## LAND USE APPLICATION SUMMARY

*Property Location:* 2806 and 2810 Park Ave  
*Project Name:* Park Ave Flats  
*Prepared By:* Shanna Sether, Principal City Planner, (612) 673-2307  
*Applicant:* Valarian, LLC  
*Project Contact:* Michael Margulies  
*Request:* To construct a new three-story, forty-unit multiple-family dwelling.  
*Required Applications:*

<b>Variance</b>	To reduce the required front yard setback along Park Ave from 17 ft. 9 in. to 15 ft. for the proposed structure.
<b>Site Plan Review</b>	For a new three-story, forty-unit multiple-family dwelling.

C2.0

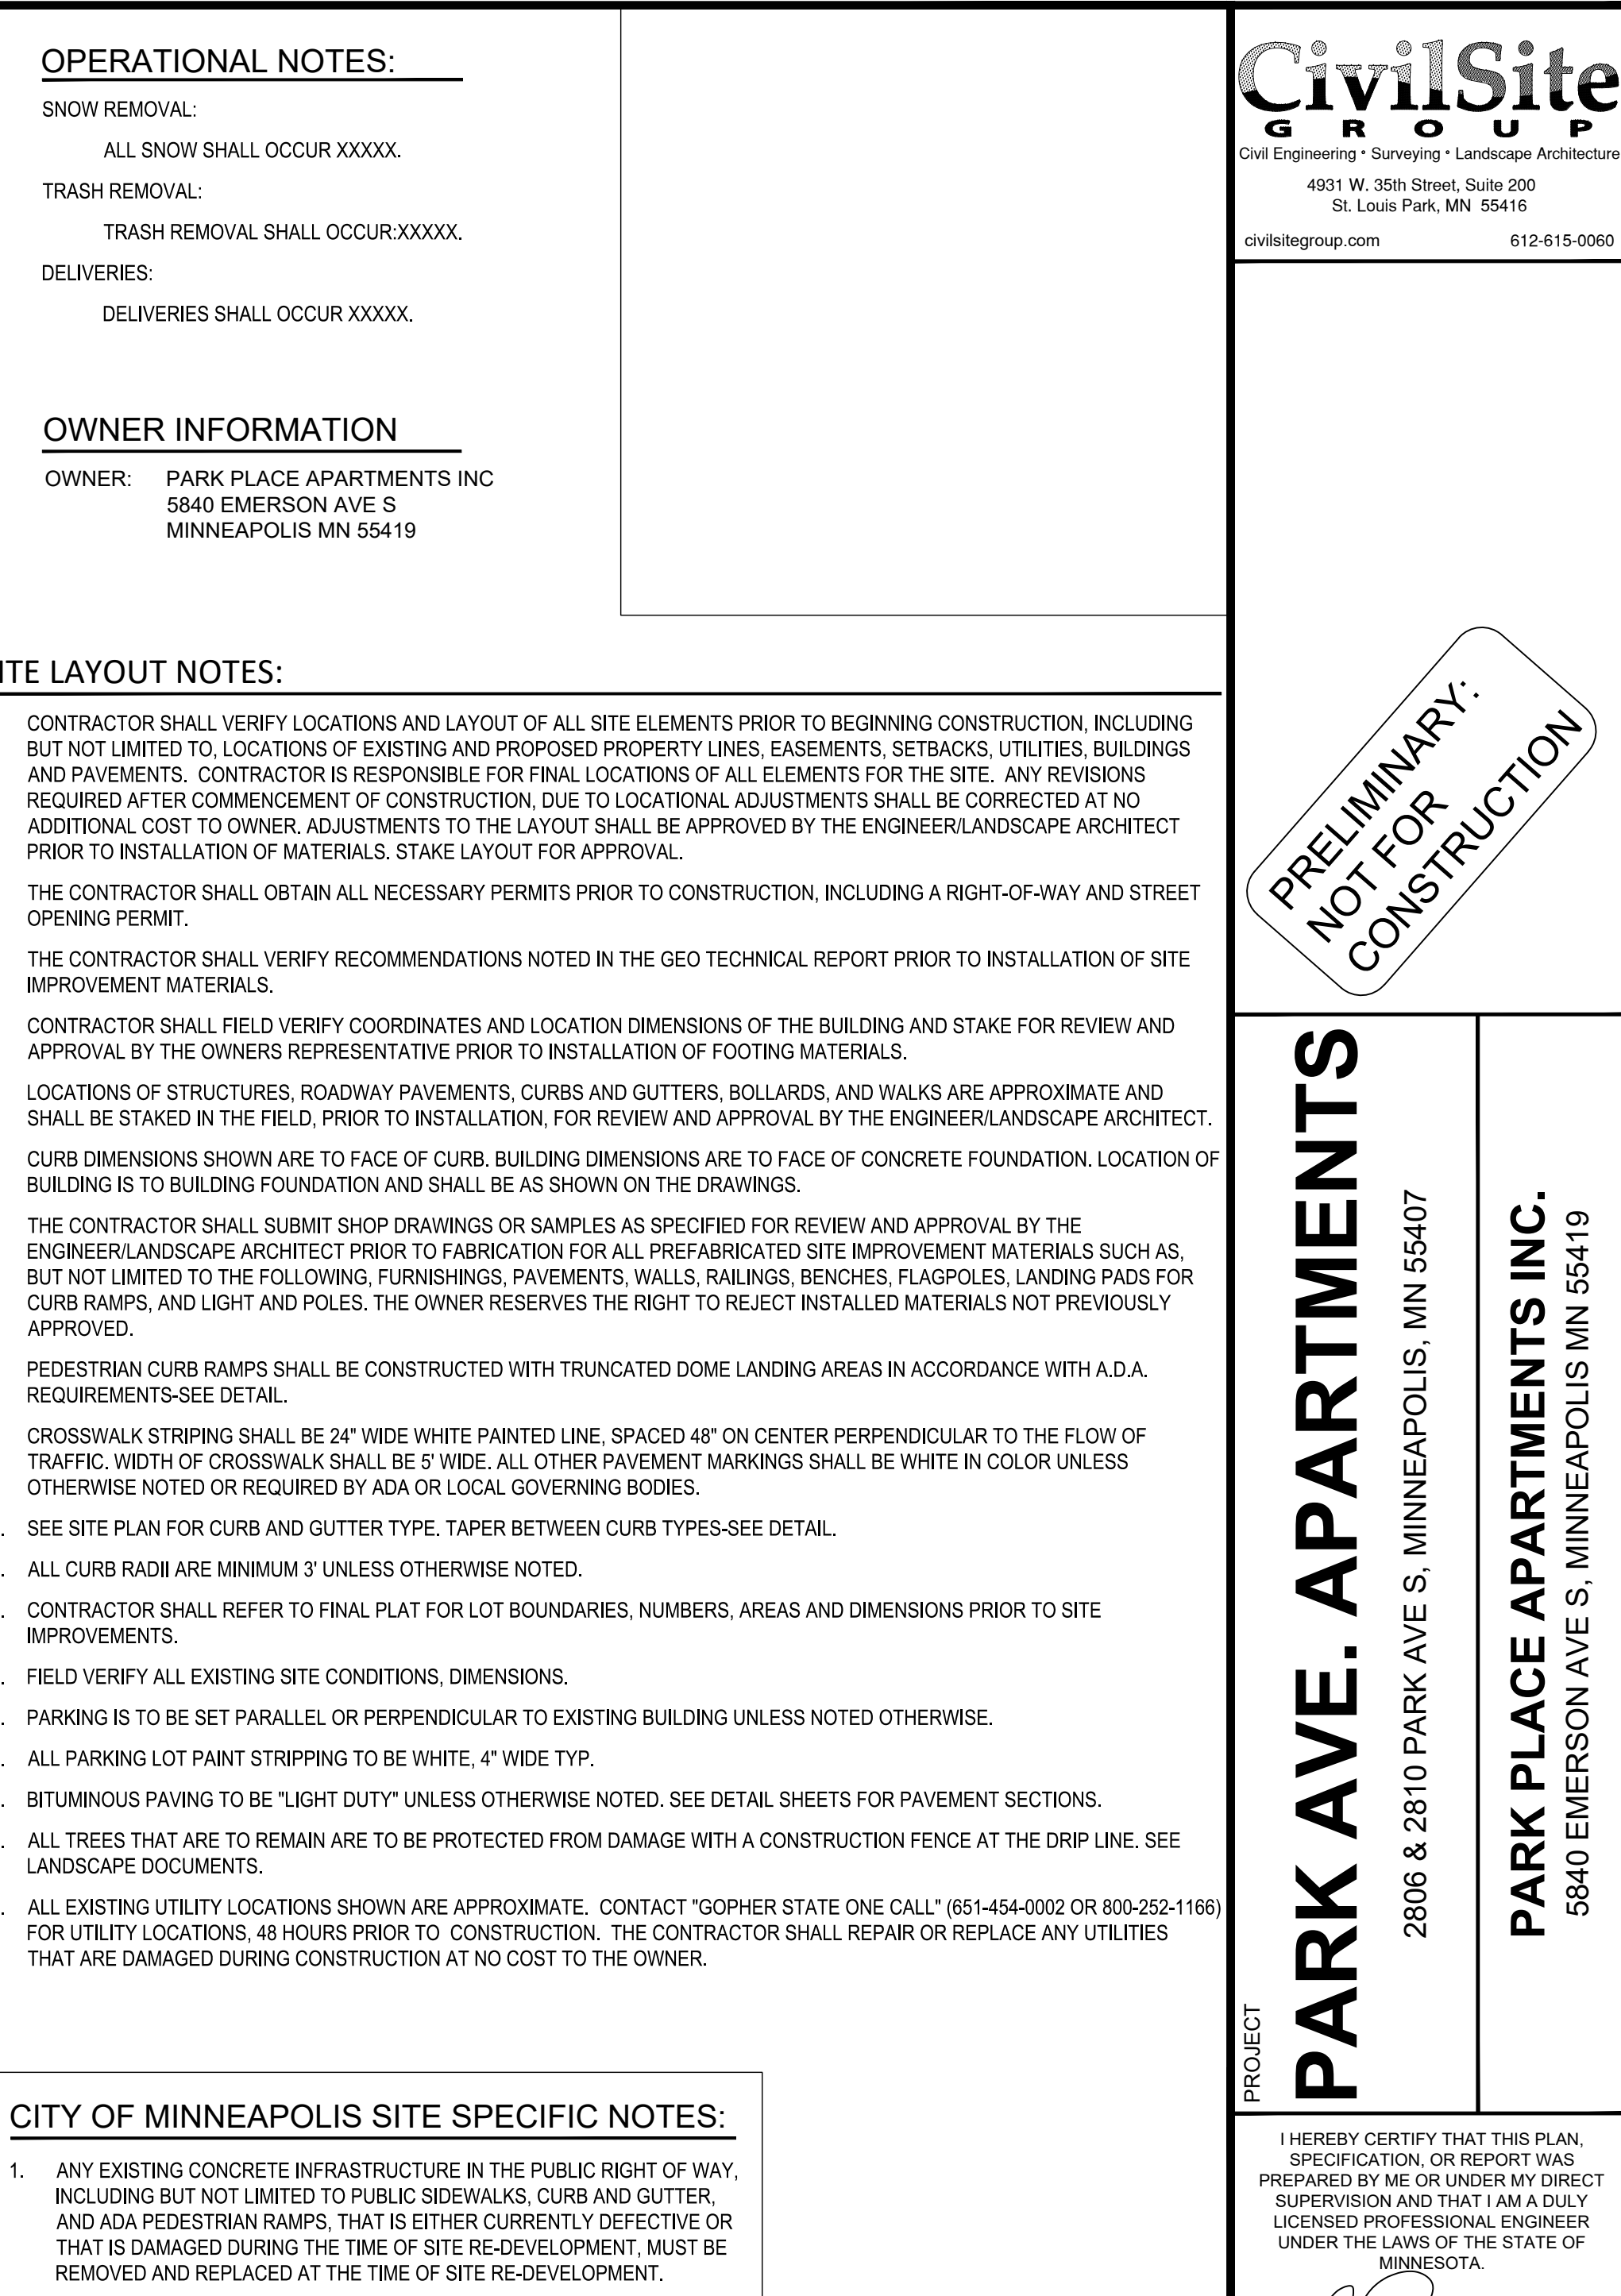
The site plan does not indicate locations of proposed electric utility transformers; it is recommended that the Applicant begin discussions with Xcel Energy as soon as possible in order to identify electric utility and transformer locations on the site plan. To the extent possible, transformers should be located on private property; it should not be assumed that the City will approve any proposed transformer location in the Public right-of-way.

The site plan appears to propose a shared use driveway with the adjacent property; the Applicant shall provide documentation of this shared use and its acceptability by the adjacent property owner.

The site plan clearly indicates removal of existing curb & gutter for utility connection purposes, however curb replacement is not indicated in the plans. Applicant shall provide for removal and replacement of all public curb & gutter within project limits rather than partial removal of sidewalk sections.

All street lighting (existing and proposed) shall be shown clearly on the site plan. If City owned street lighting exists on the proposed site it must be preserved or replaced at existing levels. Prior to site plan approval, the Applicant shall contact Joseph Laurin at 612-673-5987 to determine street lighting requirements.

## C4.0

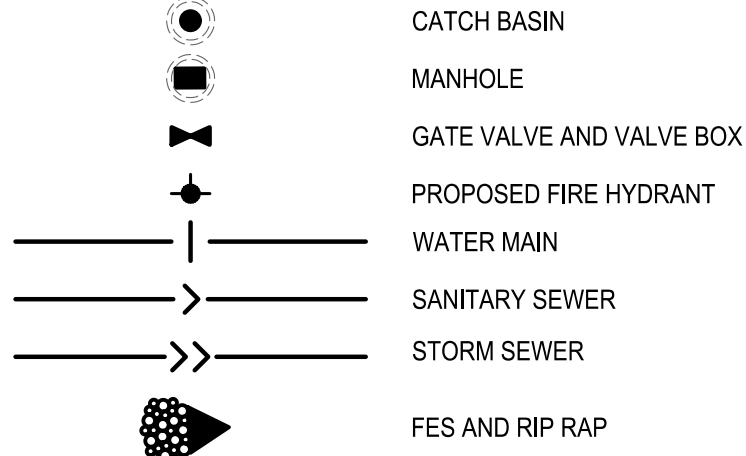
(1) City of Minneapolis Utility Notes 3 and 4, Sheet C4.0, should be removed since no stormwater management BMPs are proposed.

(1) The invert elevations of the proposed sanitary sewer connection should be completed on the plan, instead of having x's on the elevations. The invert of the proposed connection to the MH on the City main should be located between the spring line of the outgoing sewer main and no more than 2' above the crown of the outgoing sewer main.

1 WEST ELEVATION  
1/8" = 1'-0"

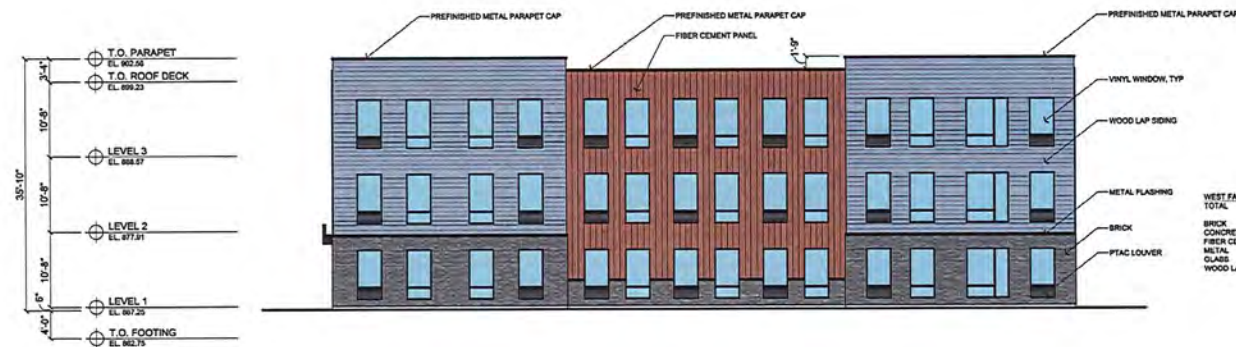
- **Blank wall.** There is a 33-ft. long blank wall on the rear elevation, at the north end of the structure. There is a dwelling unit and stairs within the 33 ft. wall and staff finds that there are opportunities to break up the blank wall with windows or other architectural features. Staff does not recommend granting alternative compliance.
- **Canopy trees.** The applicant is seeking alternative compliance to provide one canopy tree, where two are required. The applicant is proposing a total of 3 trees, one maple, one crimson spire oak and one crimson Japanese maple. The crimson spire oak reaches the appropriate height, but does not provide a canopy. Staff is recommending that the planning commission grant alternative compliance based on the amount of area near the boulevard trees and that there is a total of three trees proposed.

1. All site improvements shall be completed by June 1, 2022, unless extended by the Zoning Administrator, or the permit may be revoked for non-compliance.
2. CPED staff shall review and approve the final site, elevation, landscaping, and lighting plans before building permits may be issued.
3. The applicant shall submit the tax parcel division, combination, or lot line adjustment request form to CPED and submit proof of the filing with Hennepin County.
4. All signs shall comply with Chapter 543 of the zoning code. All signage requires a separate permit from CPED.
5. The applicant shall provide architectural feature, recesses, projects, material changes, windows or similar to break up the blank wall facing east, in compliance with section 530.120 of the zoning code.
6. The applicant shall provide a lighting plan showing compliance with section 535.590 of the zoning code.
